18VARIANCE1022

Hurstbourne Town Center

Louisville Metro Board of Zoning Adjustment

Joel Dock, Planner II

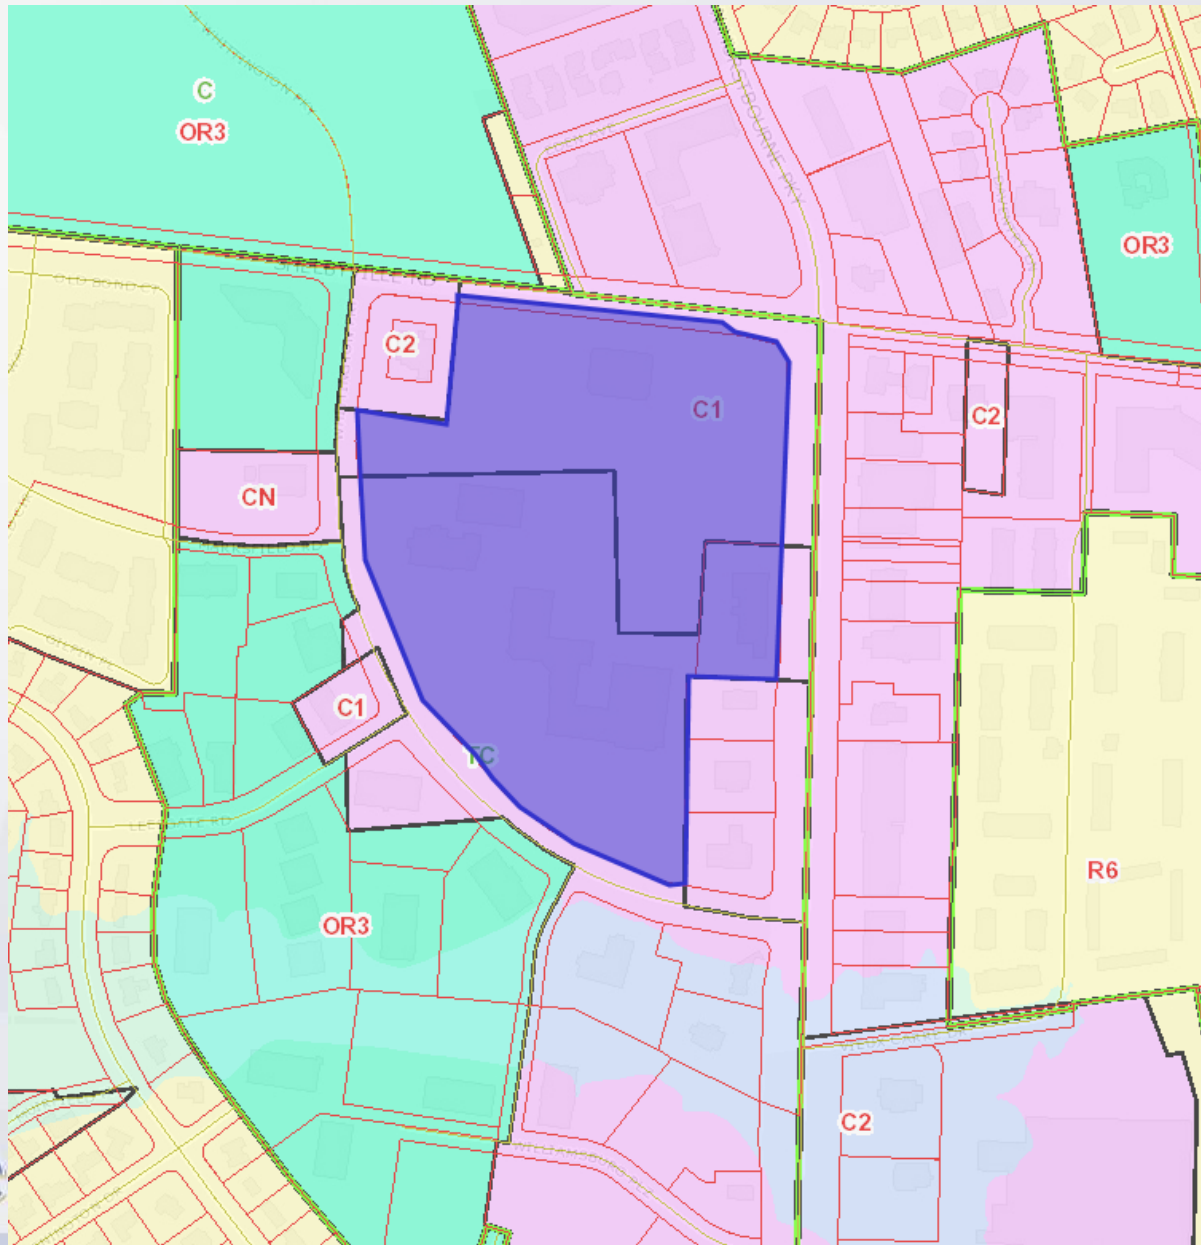
1. Variance of Land Development Code (LDC), section 5.2.4.C.3.a for buildings on Tract 1 to exceed the 15' SSY as shown on the development plan
2. Variance of Land Development Code (LDC), section 5.2.4.C.3.a for building on Tract 4 to exceed the 15' SSY as shown on the development plan
3. Variance of Land Development Code (LDC), section 5.2.4.C.3.a for building on Tract 5 to exceed the 15' SSY as shown on the development plan
4. Variance of Land Development Code (LDC), section 5.5.1.A.2 for building on Tract 6 to not be built to the corner and at the right-of-way lines as shown on the development plan

- The variance requests on Tracts 1 & 5 appear to be adequately justified, while those on Tract 4 & 6 do not appear to be justified.
- Lack of Sufficient material (renderings) resulting in an incomplete analysis
- Orientation in conjunction with the variance request does not adhere to the design principles of the Town Center form district.
- Disruption to the street wall proposed by adjacent development
- Surface parking lot creates pedestrian barrier decreasing multi-modal interaction
